Re: Northeast Nuclear Energy Company  
(Millstone Nuclear Power Station, Unit 3)  
Docket No. 50-423-LA-3

**Millstone Nuclear Power Station, Unit No. 3  
Response to Request for Additional Information,  
Spent Fuel Pool Rerack (TAC No. MA5137)**

**Response to Request for Additional Information  
Spent Fuel Pool Rerack (TAC No. MA5137)**

**Response to Request for Additional Information  
Spent Fuel Pool Rerack (TAC No. MA5137)  
Additional Questions Regarding Heavy Load Handling**

## EXHIBIT 6.5.3 RIGGING CONFIGURATION FOR RACK UPENDING

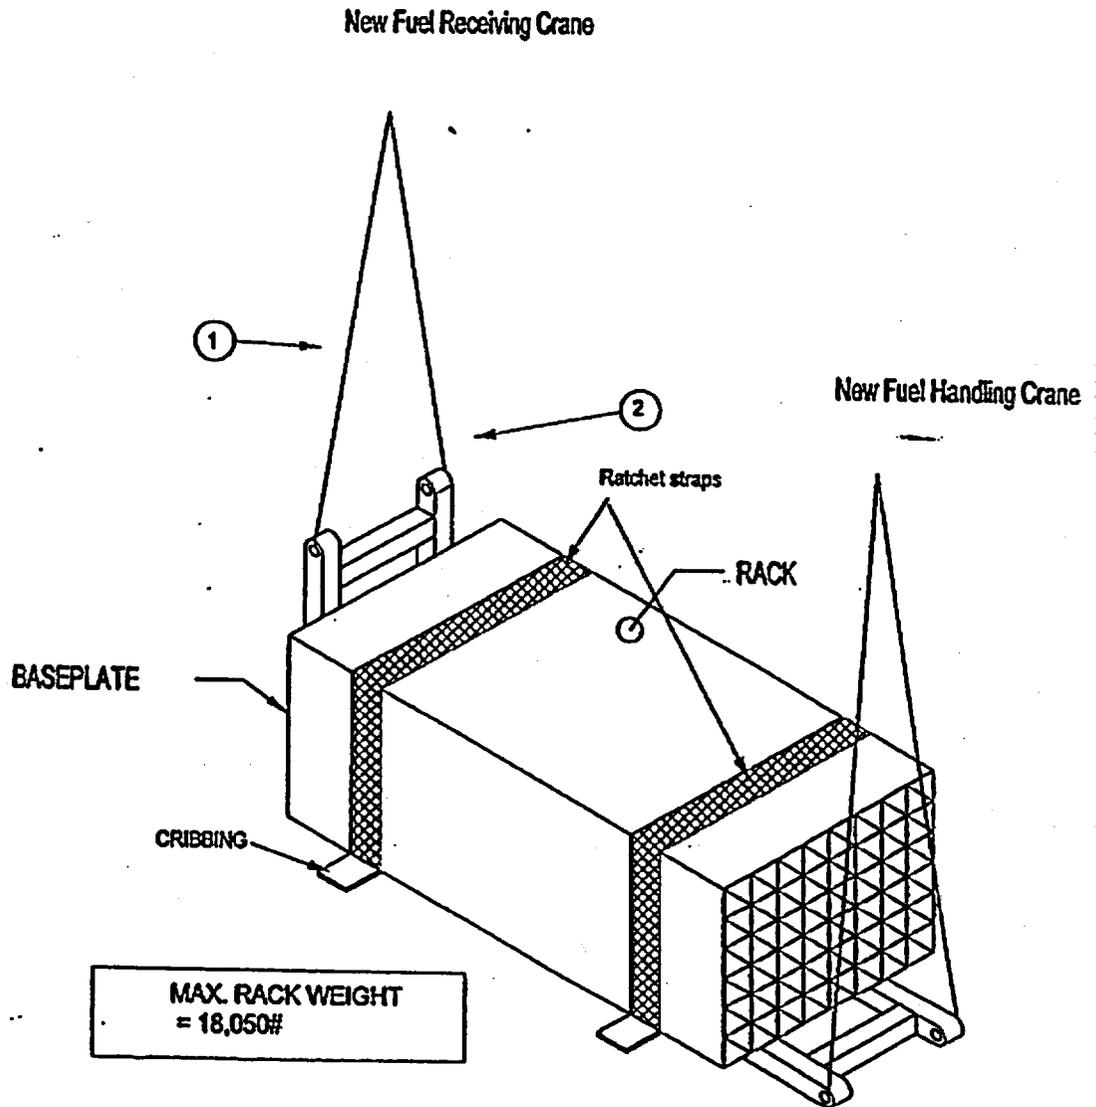
**6. Clarify the discussion at the beginning of Section 10.5 of the Holtec Licensing Report regarding upending operations.**

The Exhibit 6.5.3 of Enclosure 1 illustrates the rigging arrangement for the upending process as well as the designated cranes to be used in this process.
